BOARD OF ADJUSTMENT
CASE REPORT

STR: 9212 Case Number: **BOA-22964**

ACTION REQUESTED: Variance to allow more than 1 Accessory Dwelling Unit per lot in an RM-2 District (Sec. 45.031-D) Variance to permit the aggregate floor area of accessory buildings on a lot in an RM-2 District to exceed 40% the floor area of the primary residential structure (Sec. 45.030-B); Variance to permit a Detached Accessory Structure to cover more than 30% of the rear setback (Sec. 90.090-C.2) Variance to permit a detached accessory building to exceed 1 story or 18 feet in height and 10 feet to the top of the top plate (Sec. 90.090.C), and to be located less than 3 feet from the rear lot line (Sec. 90.090-C)

LOCATION: 1515 S CARSON AV W **ZONED:** RM-2

1 SITE PLAN
1/4" = 1'-0"

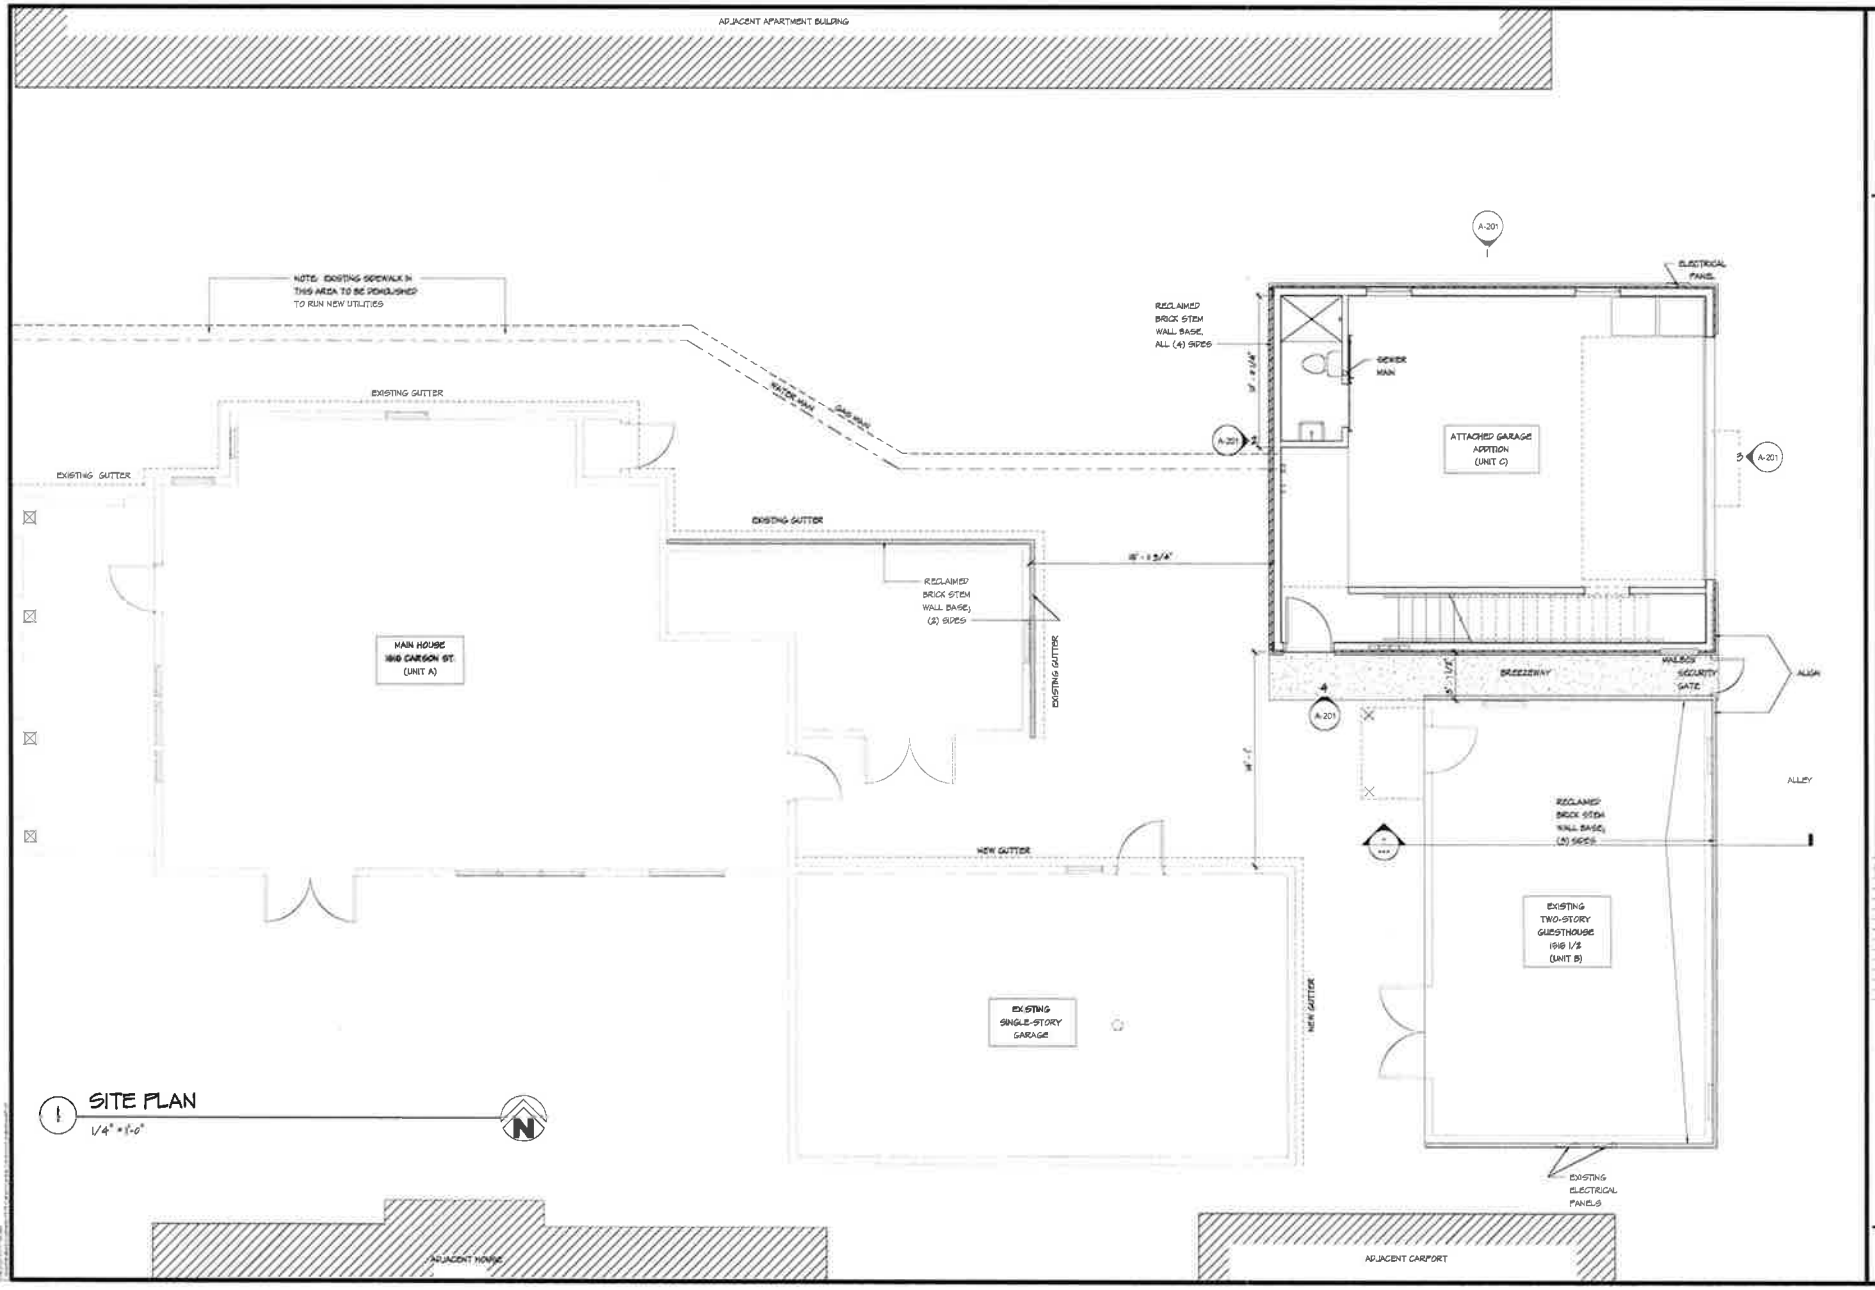
accessory building is permitted to cover the required rear setback. Revise and resubmit your plans indicating the proposed accessory building in the required rear yard to 180 sf or obtain a Variance from the BOA to allow more than 30% coverage in the rear setback.

Review Comments: Table 90-1 footnote [2] requires accessory structures to be at least 3' from side and rear lot lines. Revise plans to indicate compliance or apply to BOA for a variance to allow less than a 3' rear setback for the structure and the second-floor balcony.

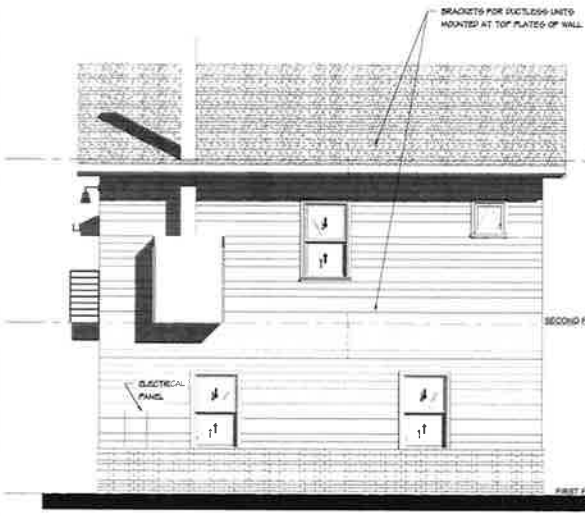
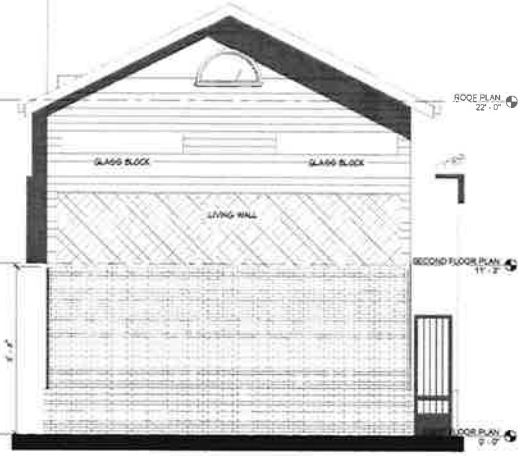
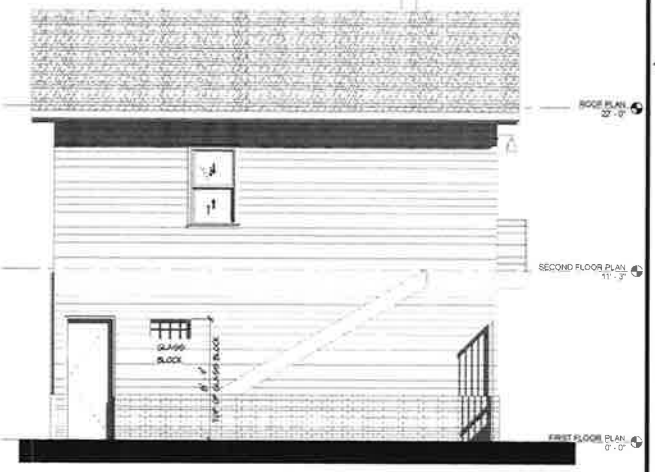
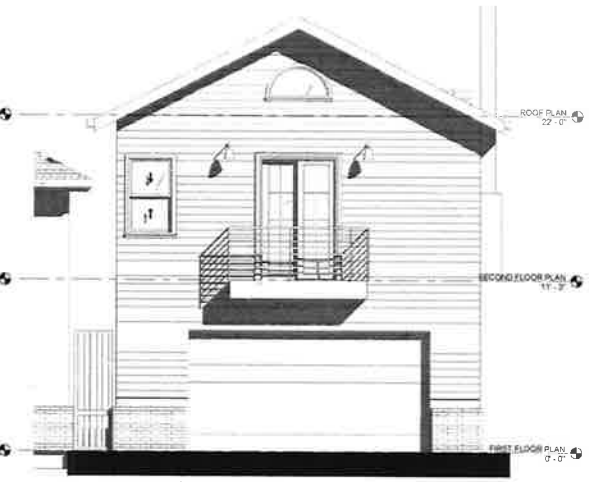
Review Comments: Revise and resubmit your plans providing a one story detached accessory building, no greater than 18 feet in overall height and a top plate no greater than 10 feet in height. You may apply for a Variance from the City of Tulsa Board of Adjustment (BOA) to permit the proposed two story accessory building more than 18' feet above grade and exceed 10 feet to the top plate.

Review Comments: Revise plans to indicate that the detached accessory building will not exceed one story or 18 feet in height and is not more than 10 feet in height to the top of the top plate or apply to the BOA for a variance to allow an accessory structure to be more than 1 story, exceed 18 feet in height and be more than 10 feet in height to the top of the top plate
